10/612,848

Office Action Summary

BISWAS ET AL.

DETAILED ACTION

Figure 1 of Furuya et al

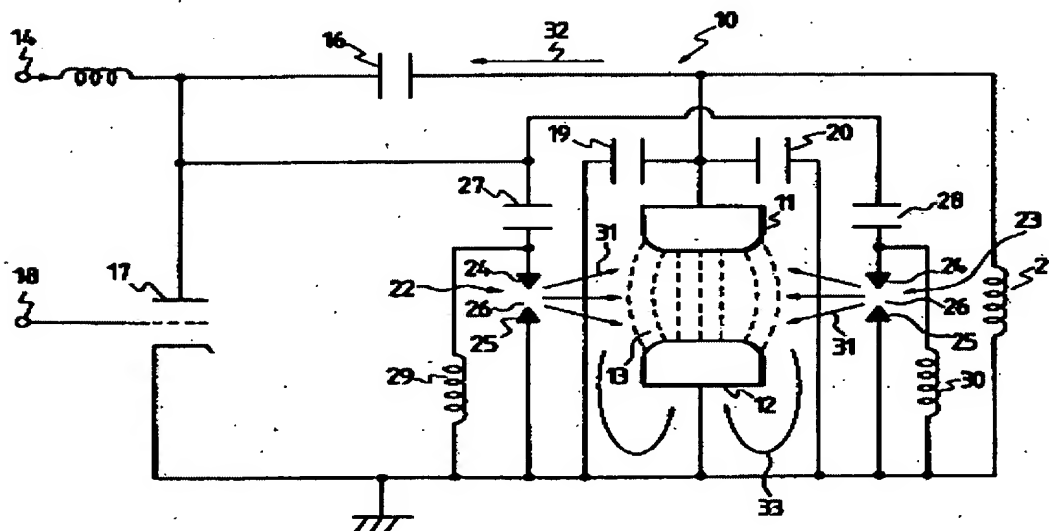
Furuya et al illustrates in figure 1 a gas laser (10) having an electric circuit [applicant's pulser] formed by the terminal (14), switch (17), capacitors (16,19,20,27,28) and charging coils (21,29,30), column 3 lines 10-56. The gas laser also having a pair of discharge electrodes (11) and (12) [applicant's pair of electrodes], a gas medium within a pressure container (not shown) column 2 lines 62-68 and preionizers (22) and (23) [applicant's suitable means] for preionizing the laser gas, column 3 lines 57-61. Figure 1 illustrates a charging coil (21) [applicant's means to isolate] between capacitor (16) [applicant's sustainer pulse] and capacitors (19) and (20) [applicant's spiker]. Column 5 lines 12-28, discloses a delay [applicant's means to delay] in time between the

In figure 1 Furuya et al illustrates profiled electrodes (11) and (12) with rounded edges.

In figure 1 Furuya et al illustrates a switch (17) [applicant's single switch] and terminal (14) receiving high-voltage electric energy from a power supply, column 3 lines 10-17.
